187th session

Proposal for Supplement 7 to 03 series of amendments to UN Regulation No. 51 (Noise of M and N categories of vehicles)

Submitted by the Working Party on Noise and Tyres*

- 3.2.3. Test site - local conditions (see Appendix 1 of Annex 3, Figure 2)

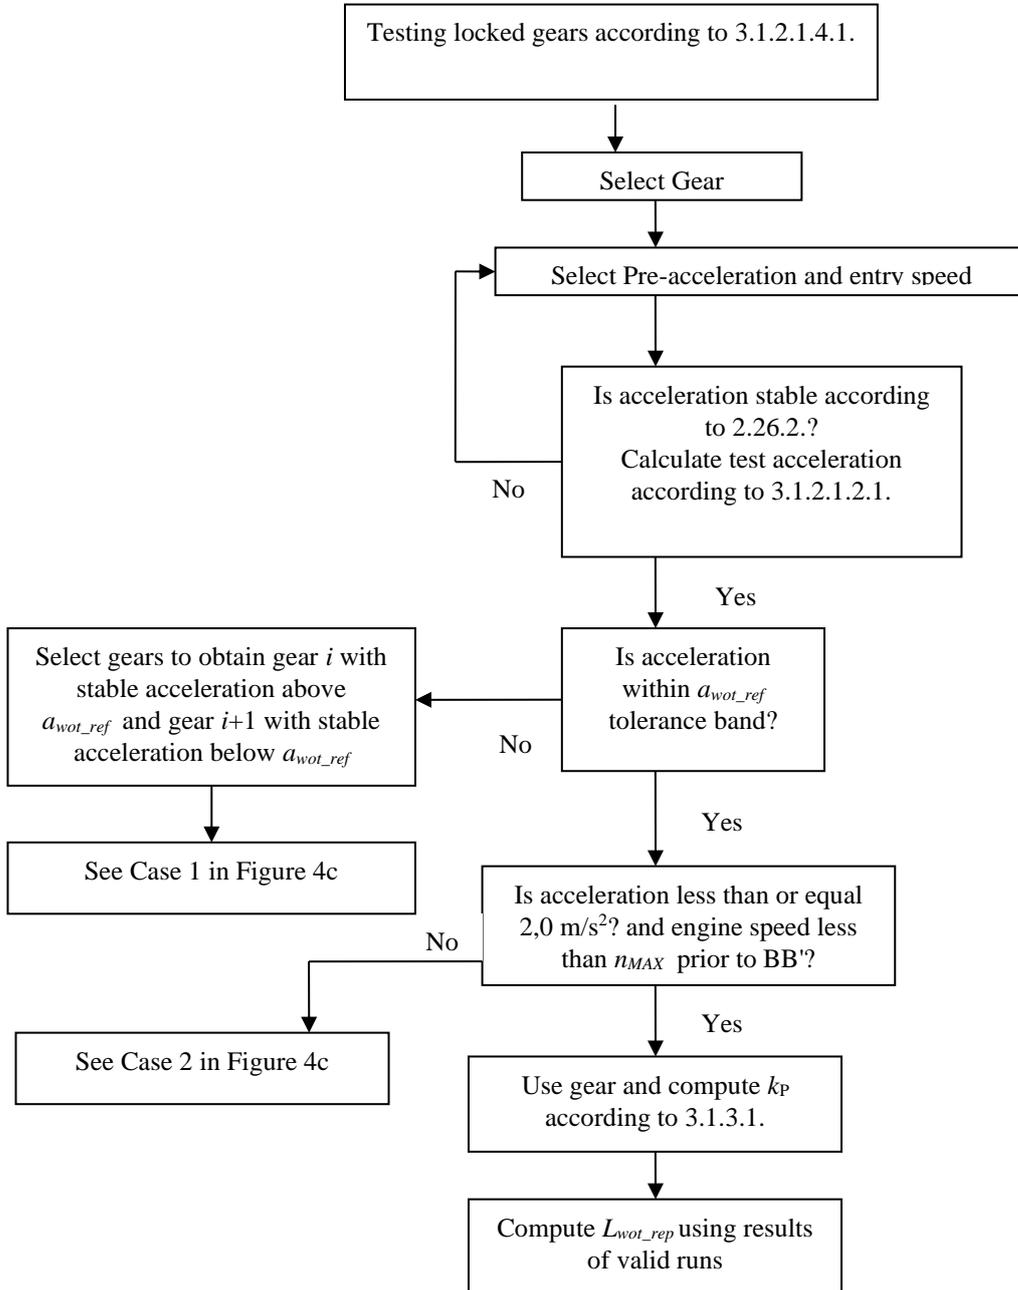
Paragraph 3.2.3., amend to read:

"Figure 4c
**Flowchart for vehicles tested according to paragraph 3.1.2.1. of Annex 3 to this Regulation –
 Gear selection using locked gear PART 2**

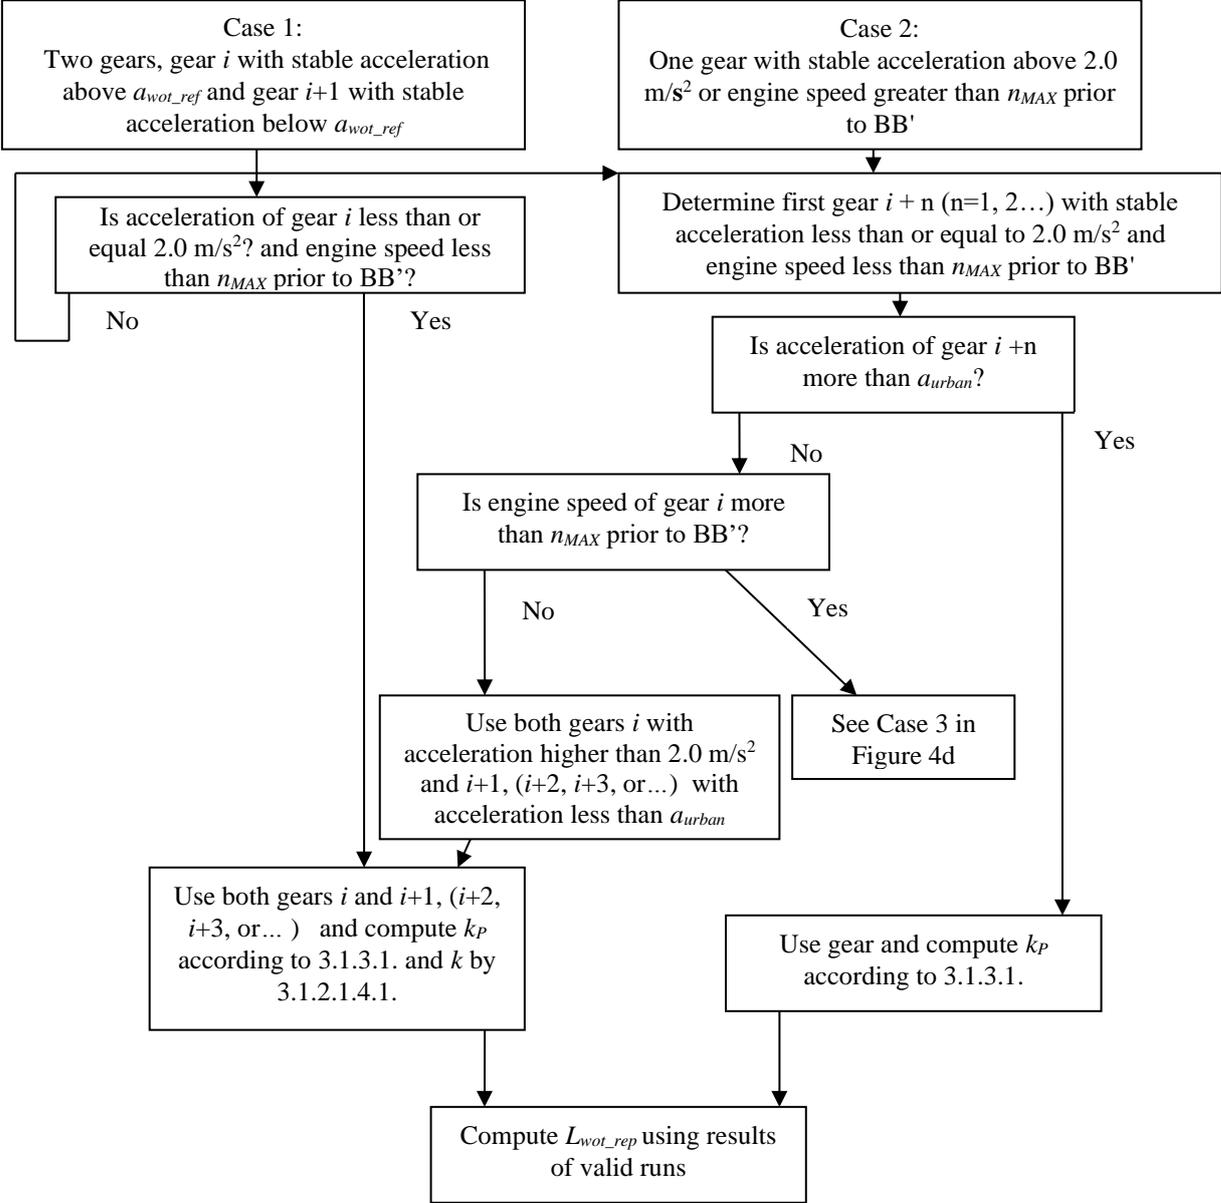
Annex 3 – Appendix 1 (renumbered), Figure 4c, amend to read:

Flowchart for vehicles tested according to paragraph 3.1.2.1. of Annex 3 to this Regulation – Gear selection using locked gear PART 3

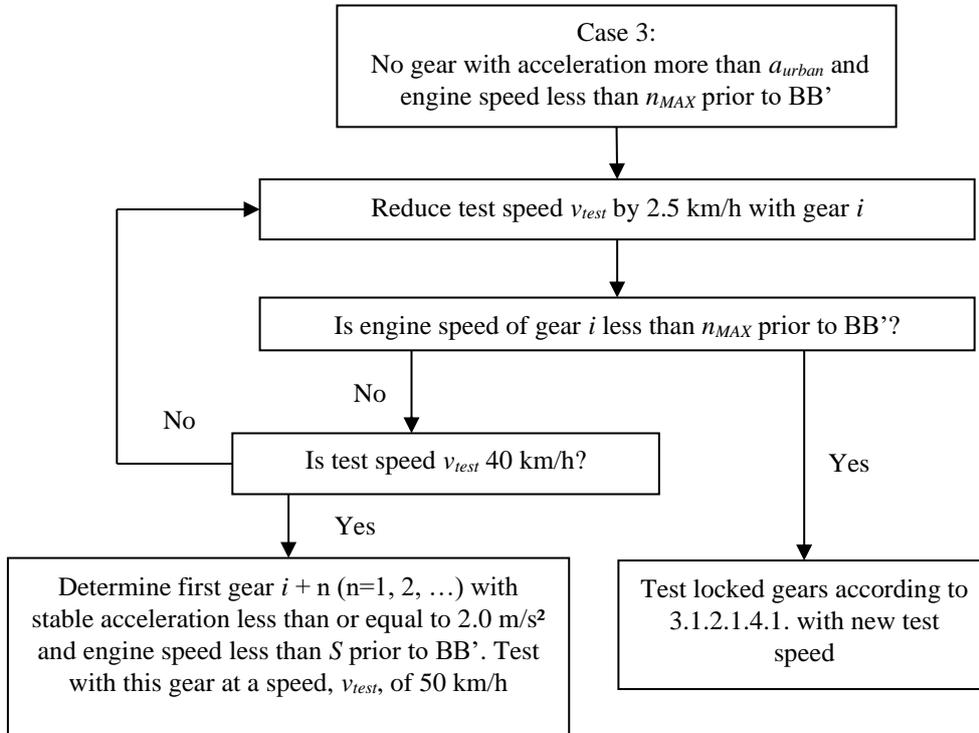
Annex 3 – Appendix 1 (renumbered), Figure 4d, amend to read:

"Figure 4e
**Flowchart for vehicles tested according to paragraph 3.1.2.1. of Annex 3 to this Regulation –
 Gear Selection using non-locked gears**

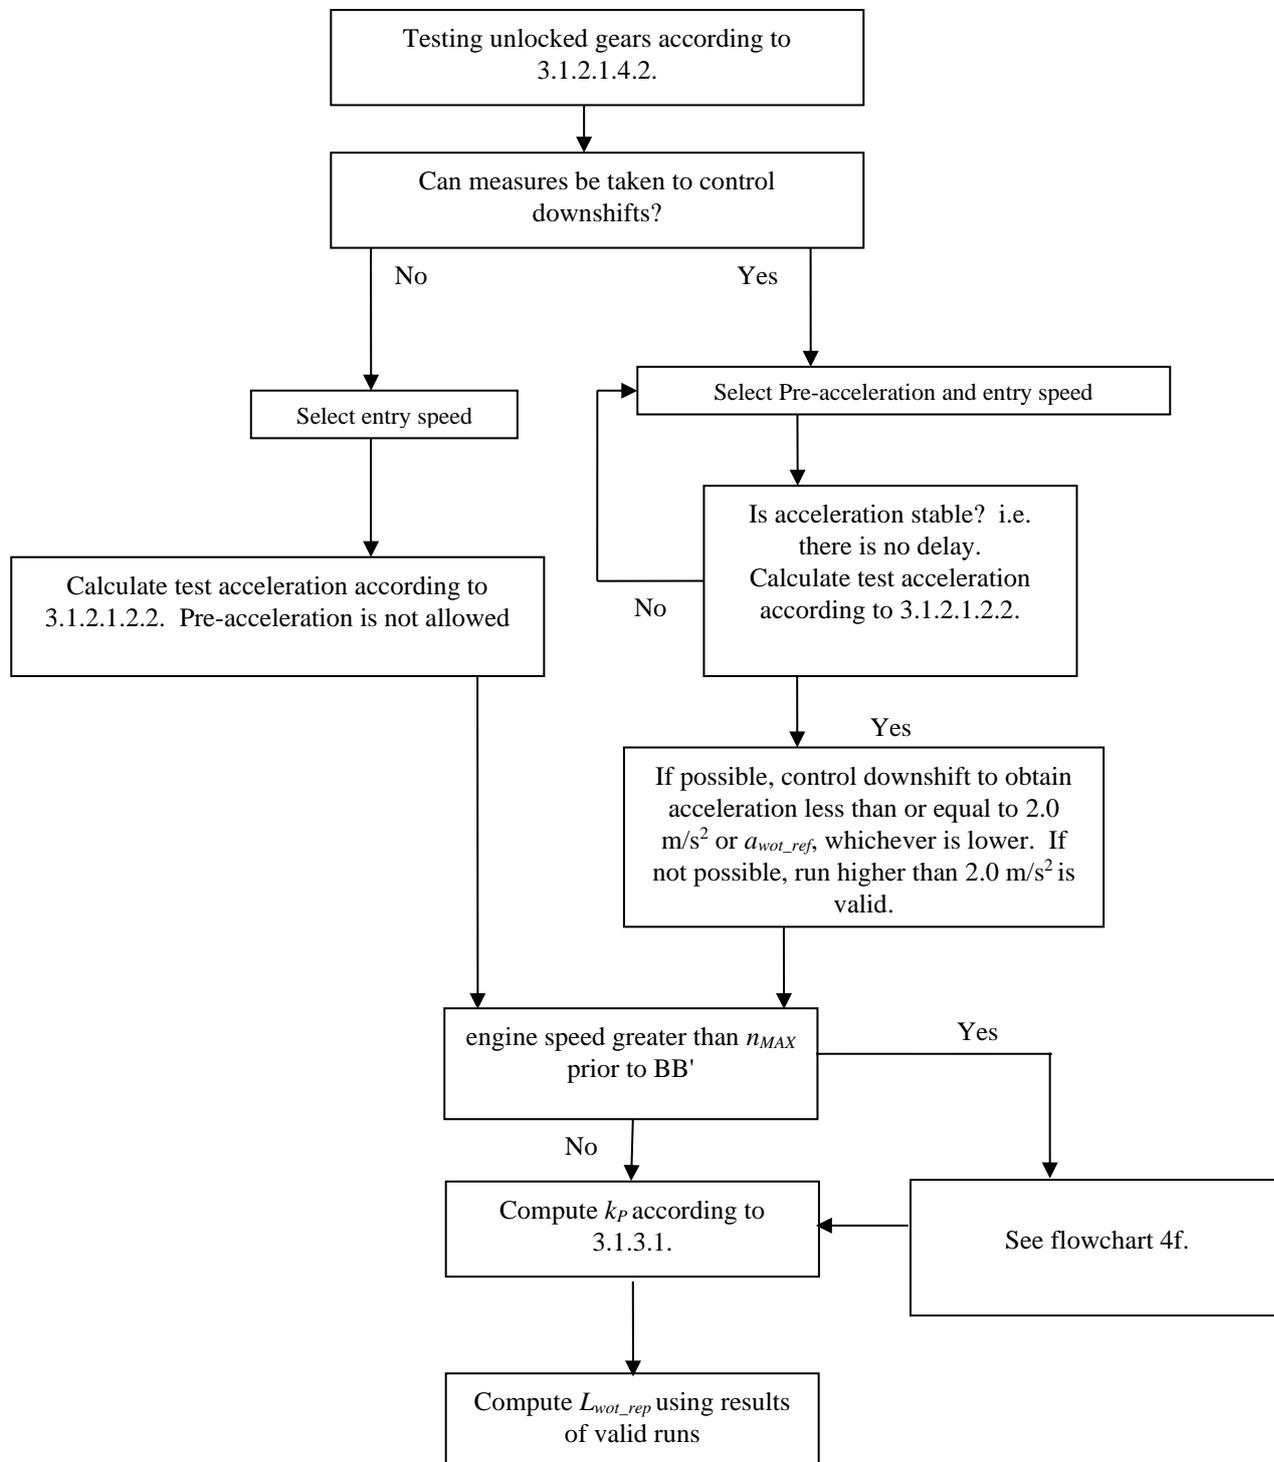
Annex 3 – Appendix 1 (renumbered), Figure 4e, amend to read:

Flowchart for vehicles tested according to paragraph 3.1.2.1.4.2. of Annex 3 to this Regulation – Gear Selection using non-locked gears

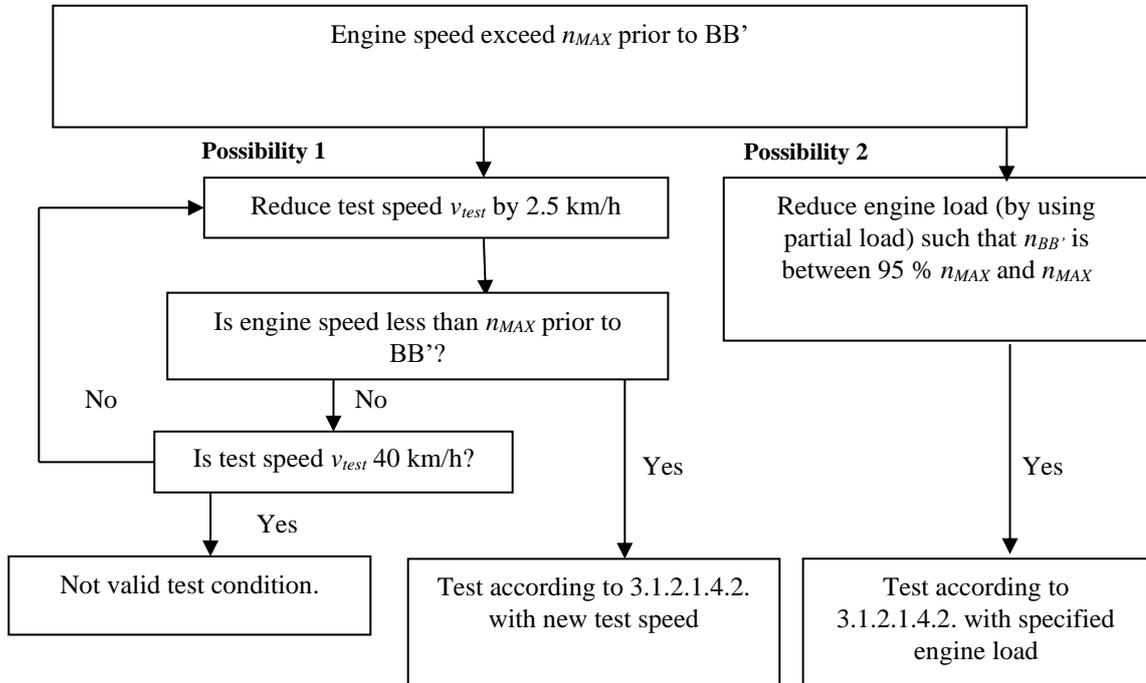
Annex 3 – Appendix 1 (renumbered), add a new Figure 4f, to read:

Figure 7a
Flowchart for vehicles tested according to paragraph 3.1.2.1. of Annex 3 to this Regulation – Correction of pass-by measurements for temperature and if applicable for test track differences

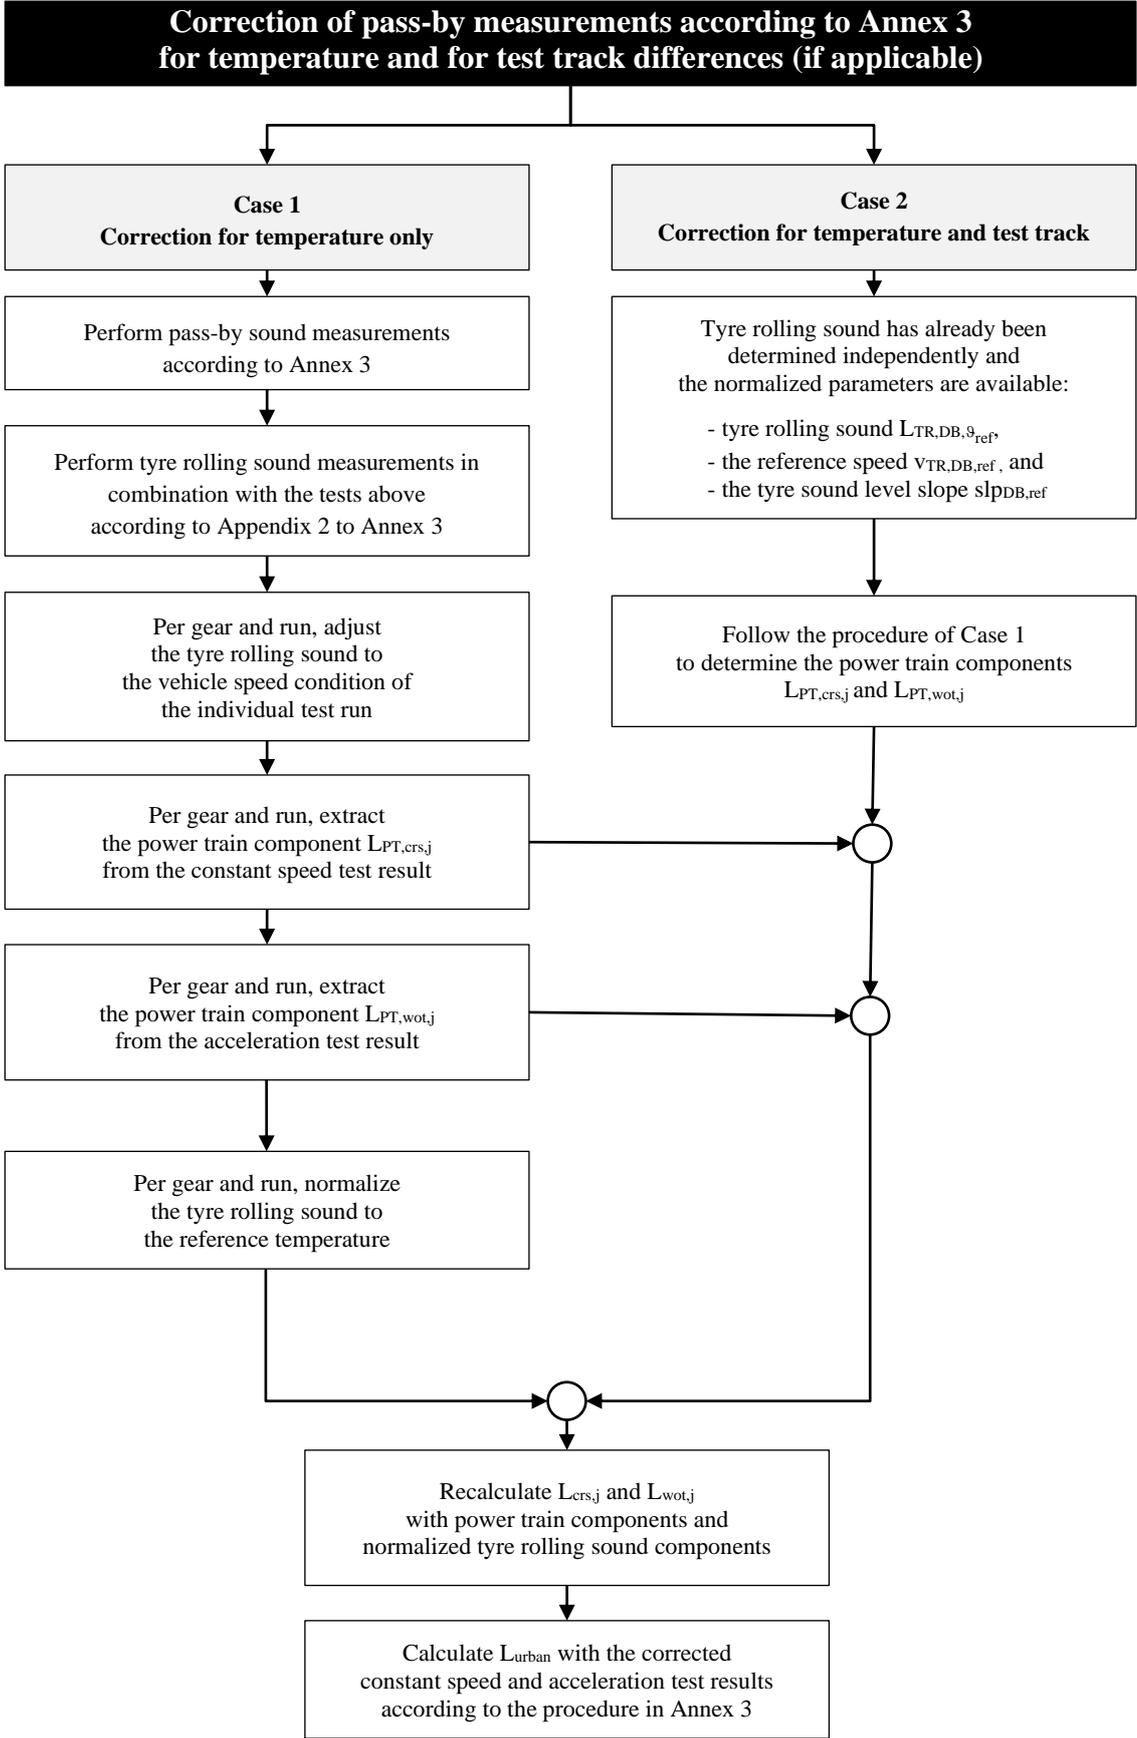
Annex 3, add a new Appendix 2 to read:
